**City of Springfield
Development and Public Works Department**

August 4, 2014

**Addendum Number 2 to the Contract Documents for the
Invitation to Bid for P21101; Downtown Lighting – Phase 1**

PROJ #	P21101
SHEET #	SL-TM427

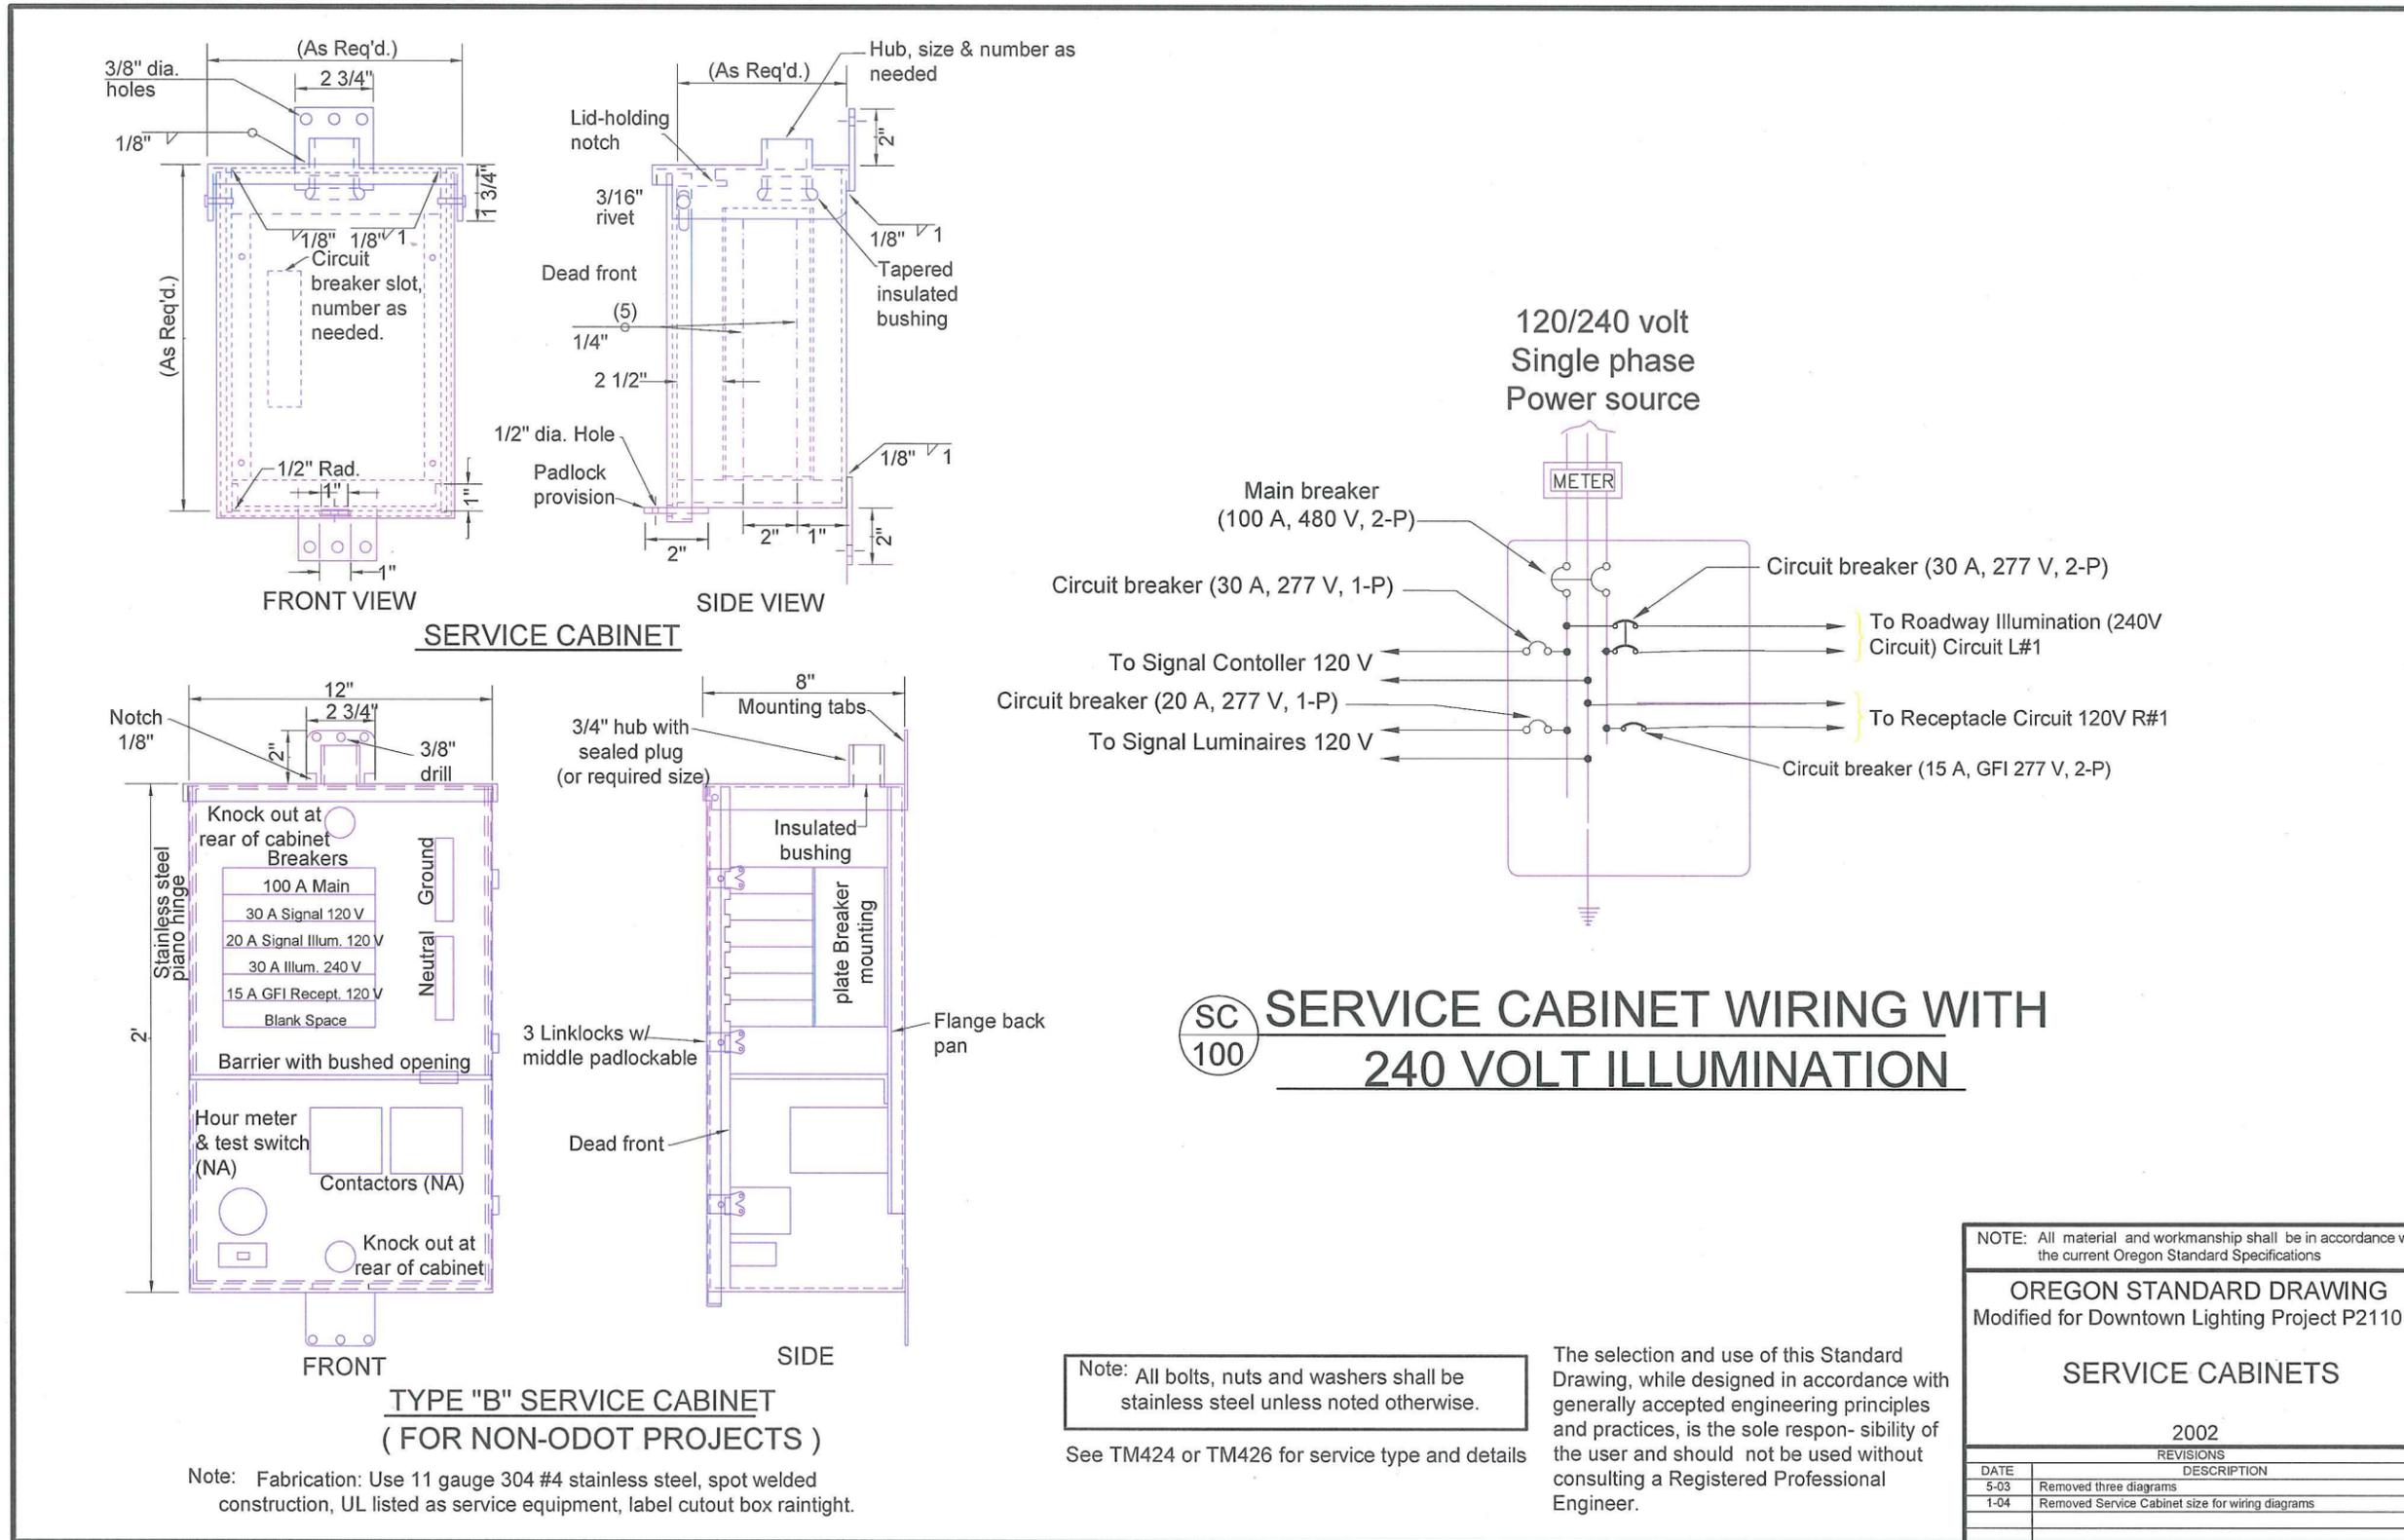
- 5.) Drawing TM485 Service Cabinets and Service Cabinet Wiring Details is deleted in its entirety.
 - 6.) Drawing SL-TM427 Service Cabinet dated 08/04/14 is a new drawing added to define the SC100 Service Cabinet for the 6th Street traffic signal. See Attachment 2 to this addendum.

Bid Item No. 0606 – Remove and Replace a 100amp Service Cabinet - Scope: This work shall include all materials and labor to remove an existing pole mounted service cabinet, and install, test, and place in service a 120/240VAC, Pole Mounted 100amp Service as shown on Sheet SL-TM427.

- 1.) Removal of the existing 120VAC, 70amp pole mounted service cabinet and meter base located on the southwest traffic signal pole at Main Street and 6th Street.
- 2.) Install a 120/240VAC, 100amp, pole mounted service cabinet as shown on SL-TM427, as recommended by the manufacture, and/or as directed by the Engineer.
- 3.) Proved new service conductor from the existing SUB power into the new service, and connect the illumination and receptacle circuits as shown on Plan Sheet SL-TM427.
- 4.) The new service shall be inspected and approved for final use by the City Electrical Inspector before SUB power is connected. The City of Springfield will obtain the electrical service permit.

PROJ #	P21101
SHEET #	SL3-6

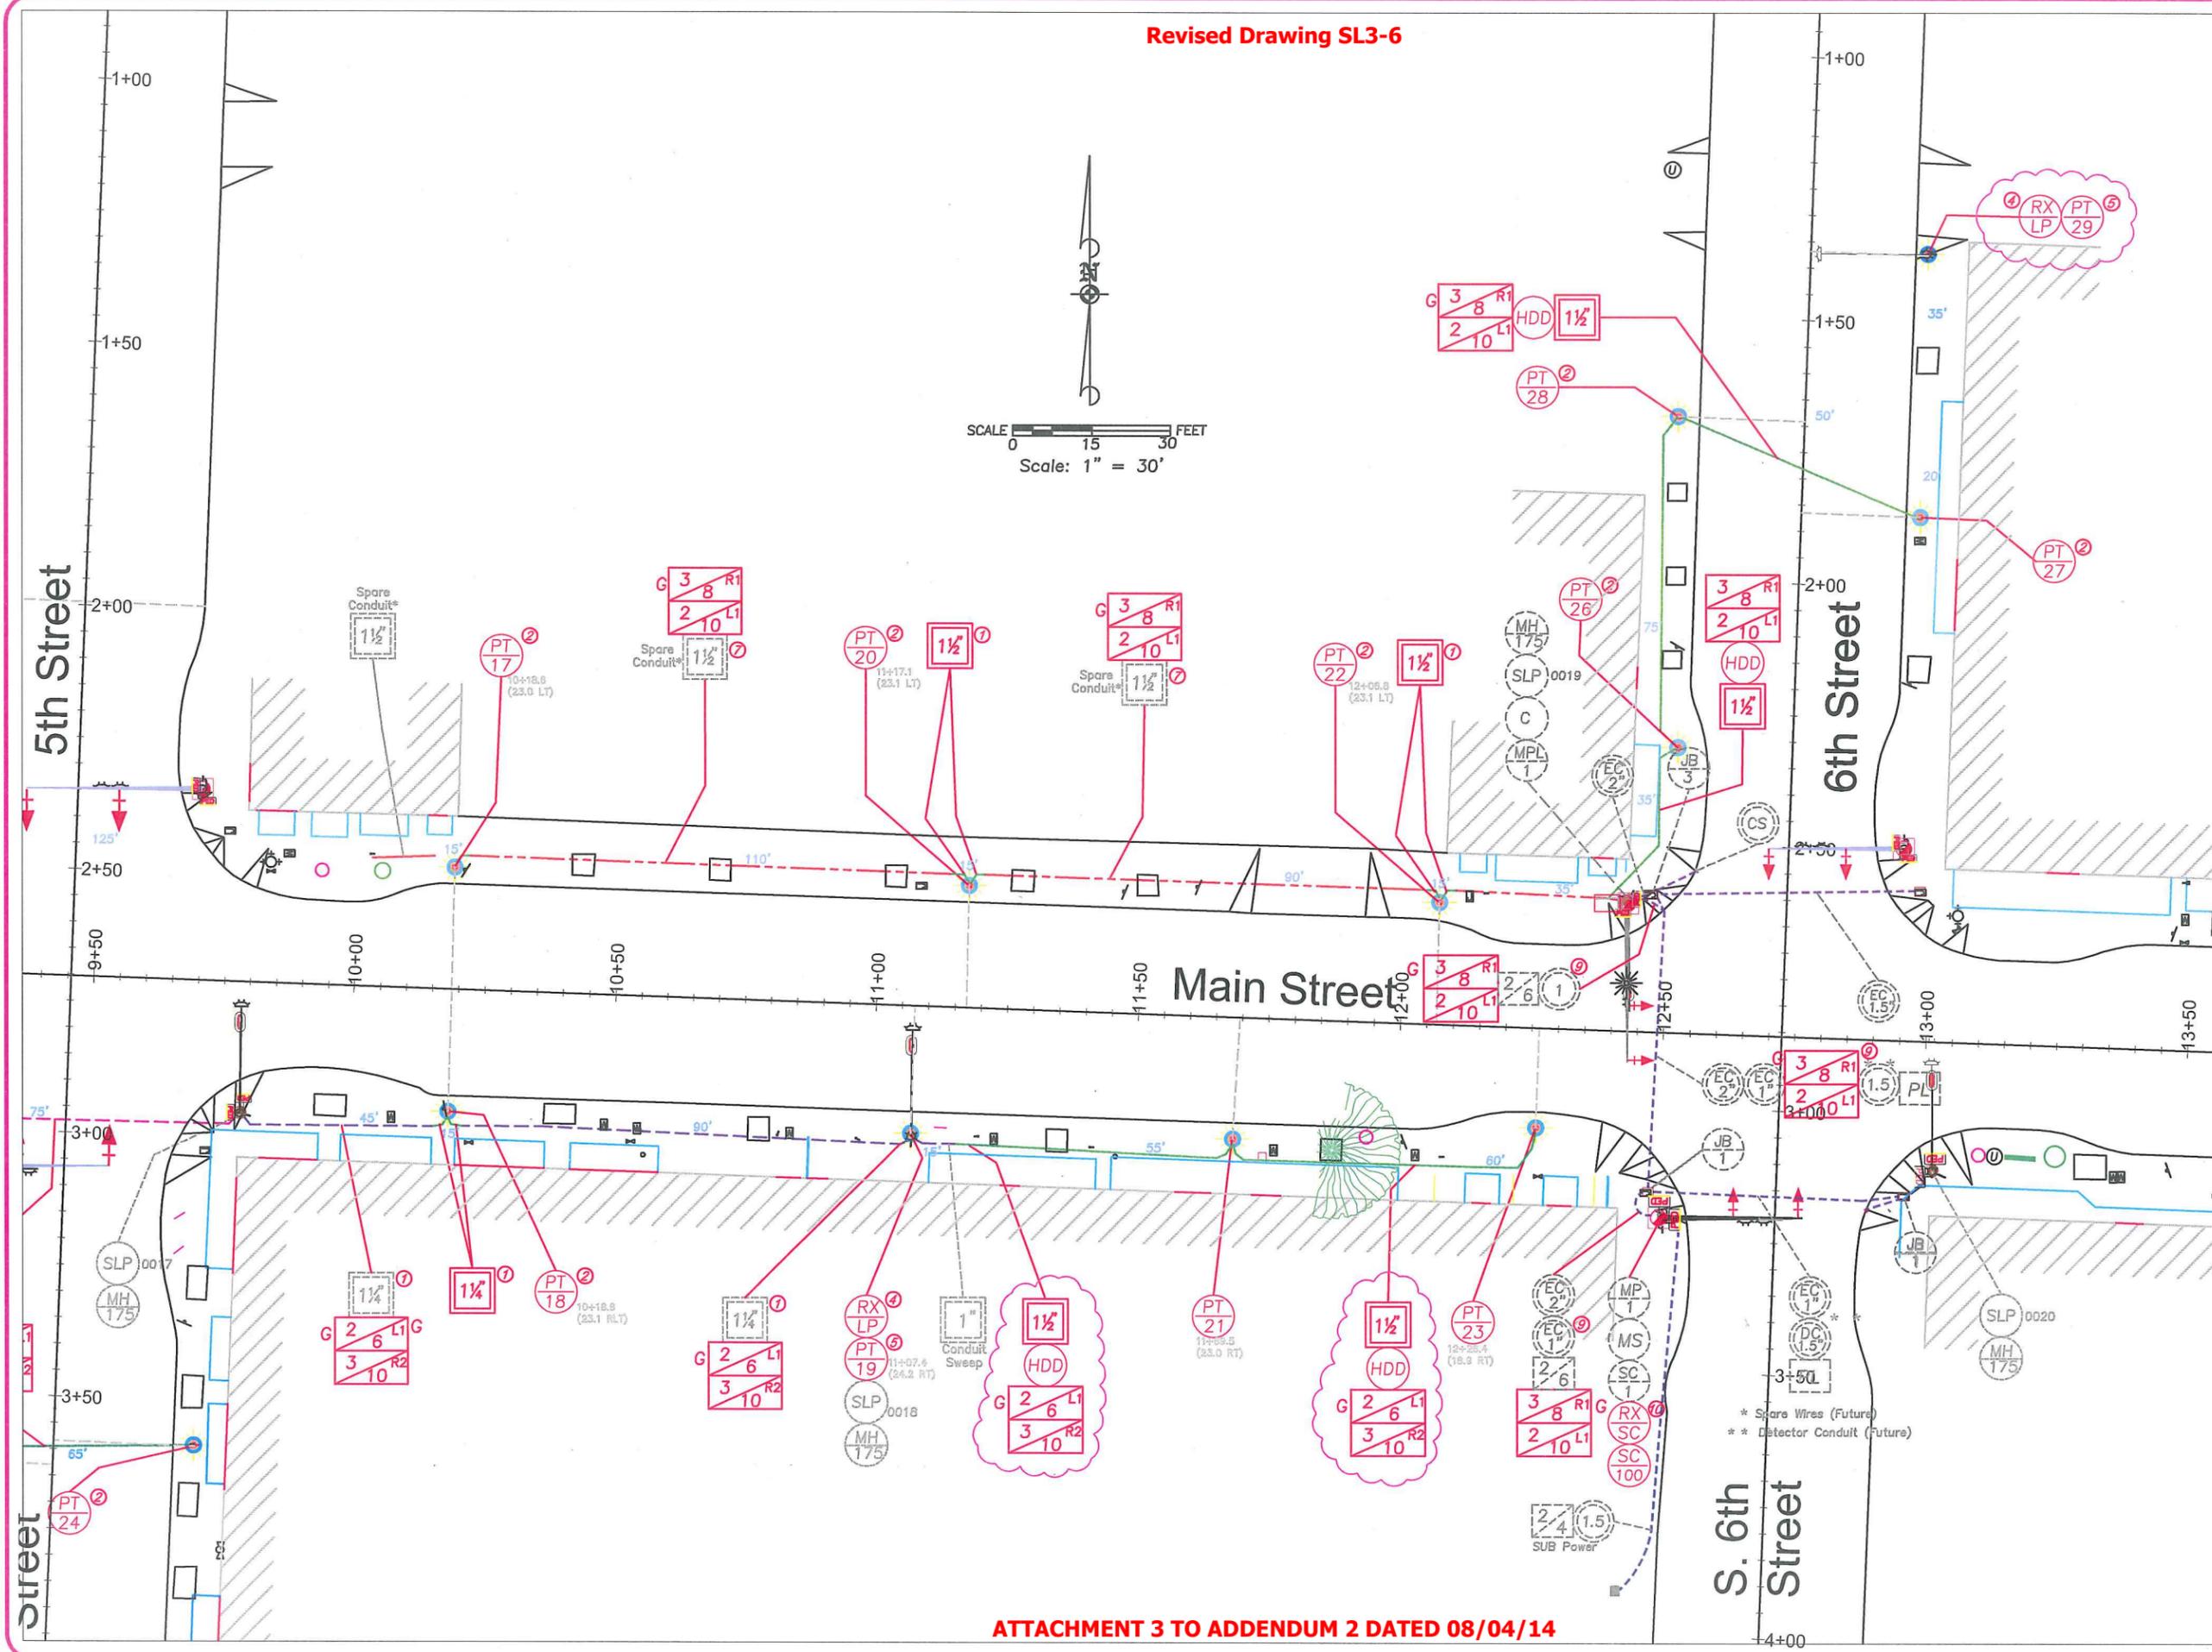
- 7.) Drawing SL3-6 Illumination Plan is deleted in its entirety and is being replaced with Drawing SL3-6 Illumination Plan with a revision date of 08/04/14. A drawing symbol (RX/LP with Note 4) was added to luminaire PT/29. It is shown with a 'cloud bubble' located in the upper right section of the drawing. Two HDD drawing symbols were added for the conduit run to PT21 and PT23. It is shown with a 'cloud bubble' located in the lower right section of the drawing. See Attachment 3 to this Addendum.
